# Tower Subdivision

City of El Paso — City Plan Commission — 7/12/2018

**SUSU18-00056 — Major Combination**

### Ranger Trail

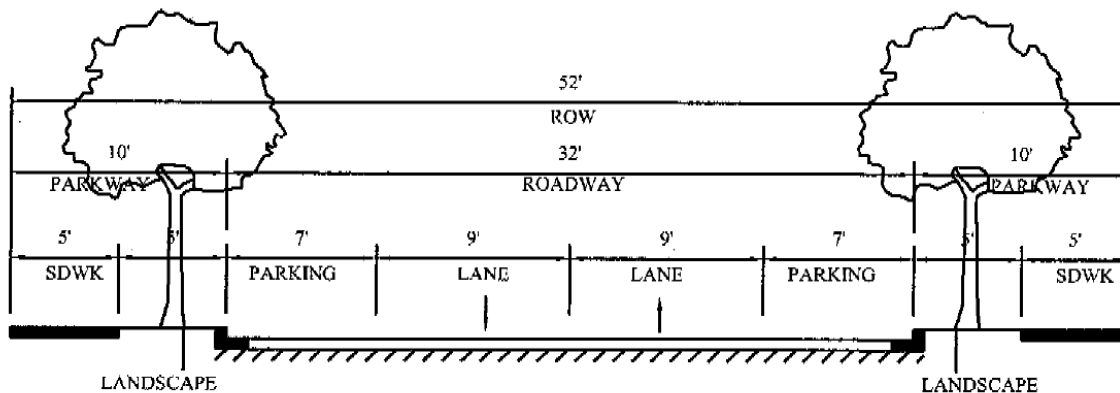
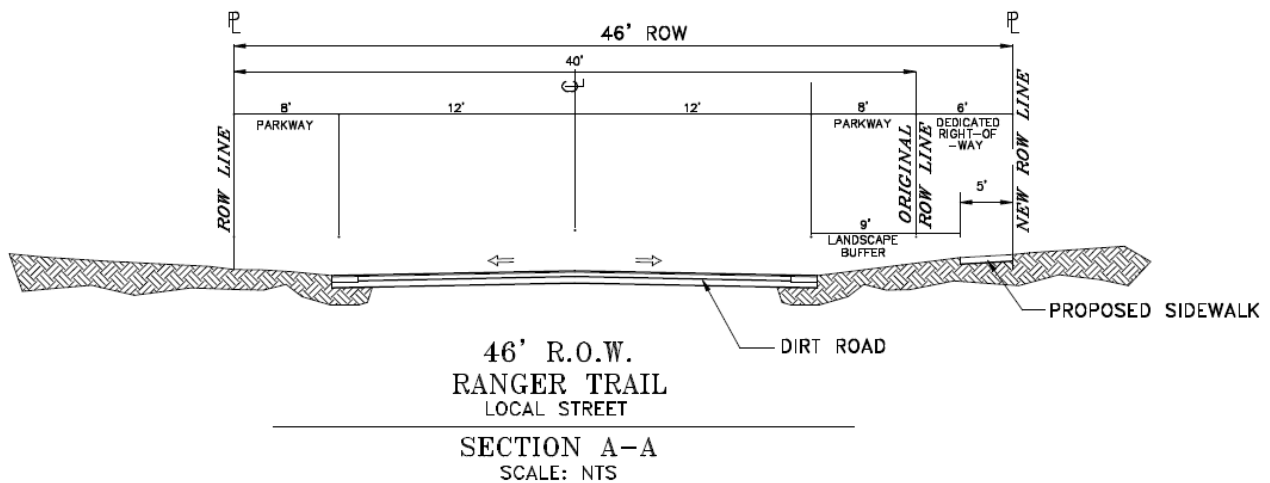
- 16' of roadway participation is required for Ranger Trail. Only 12' currently exists and it is currently unpaved. An additional 4' of roadway is required. The applicant is requesting to not be required to pave their proportionate share of the roadway.
- The proposed landscape parkway is 9' wide. This is 4' over the minimum requirement. There is enough right of way to install it to the DSC standard.
- The applicant will be installing the 5' sidewalk.

# ATTACHMENT 2

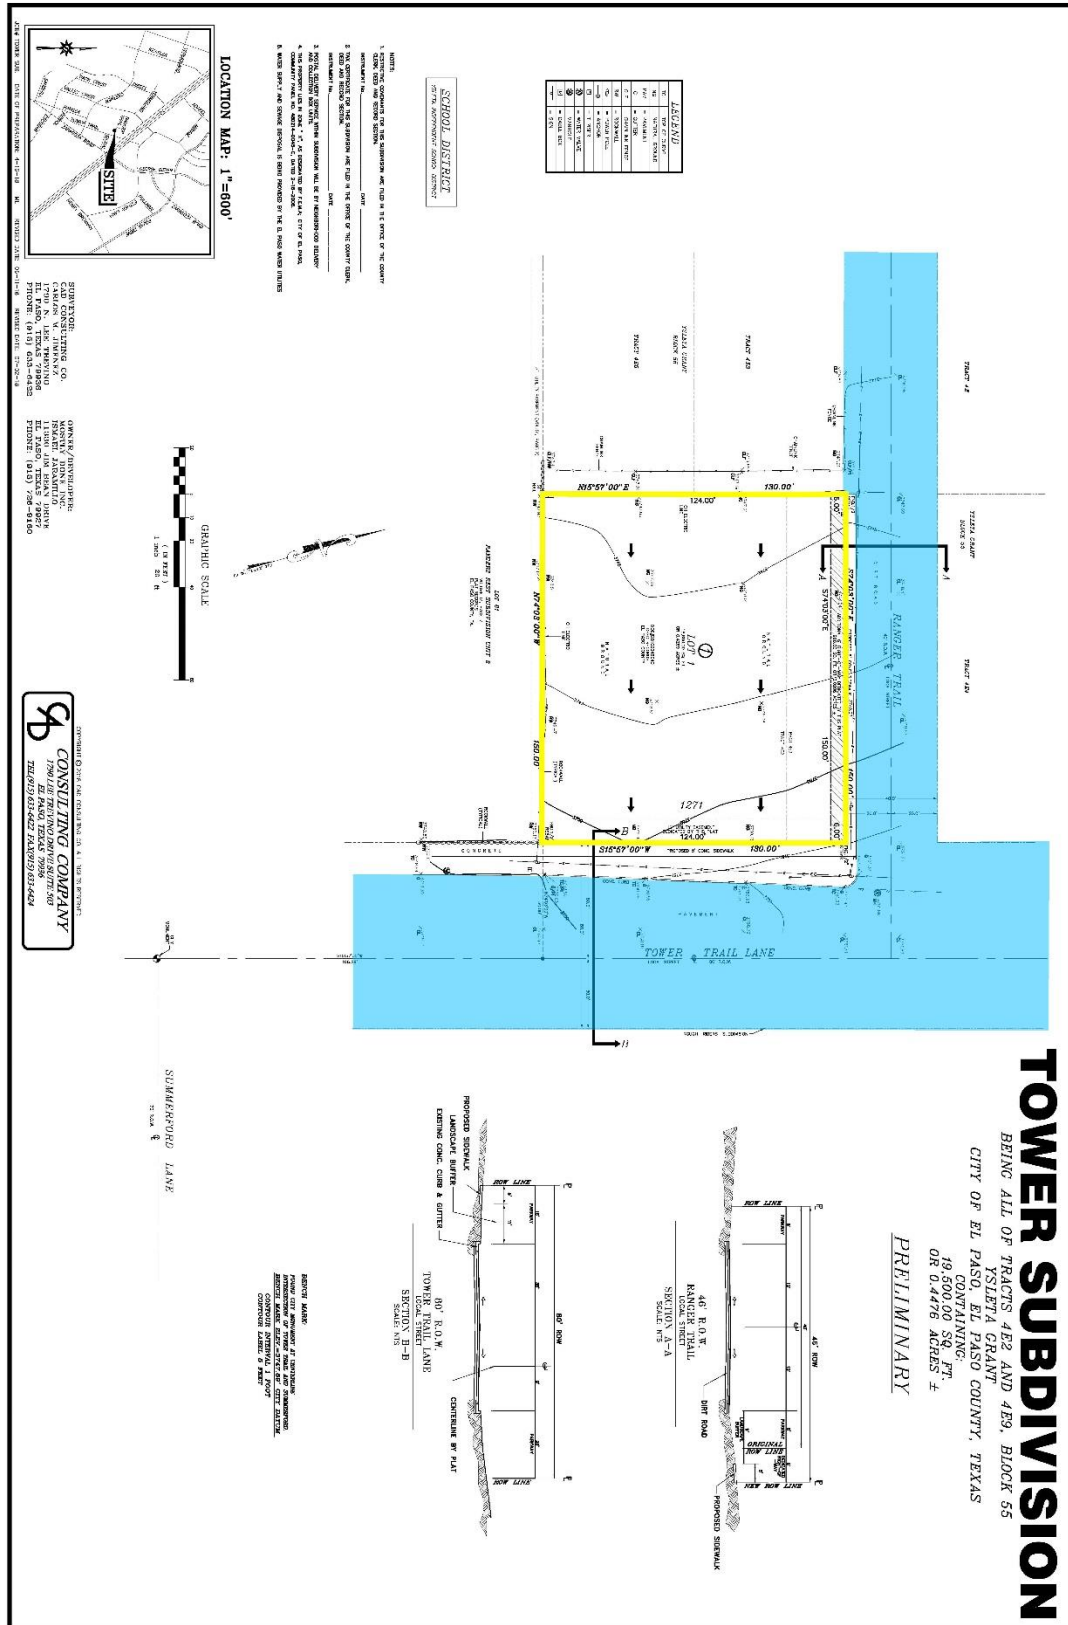
1: On the preliminary plat, the drainage flow patterns are going opposite the contours; please correct.
